LP1329 - PORTICO GP SURGERY, LINSCOTT ROAD

ADDENDUM TO STRUCTURAL REPORT – DEMOLITION AND EXCAVATION

Photograph 3 – Remedial Works at the South of the Colonade

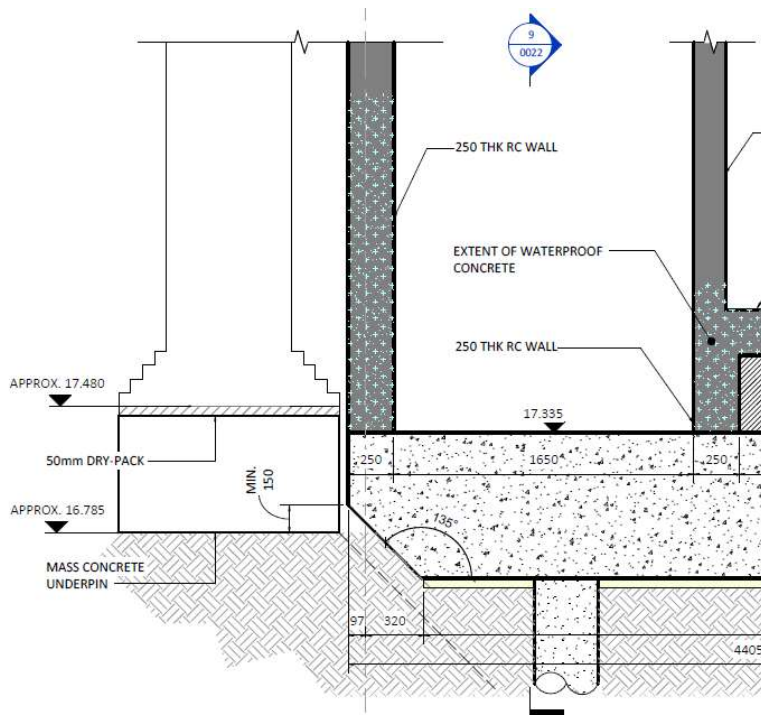
The site findings confirmed that the footings in the area are above the structural slab level in the area next to the lift of the proposed building which is 17.335 and that underpinning will be required for the area. For the underpinning to be done in safe and effective manner the full width of the wall has to be underpinning. Considering the load paths and the structural integrity we have specified that the exposed arches should be bricked to the full width of the prior to any underpinning. This will ensure that the loads are transferred to the footings and the new underpin without relying on old arch. At the top of the new and the existing masonry infill well rammed drypack should be appropriately installed. Please refer to the photograph below with the work in progress from site.
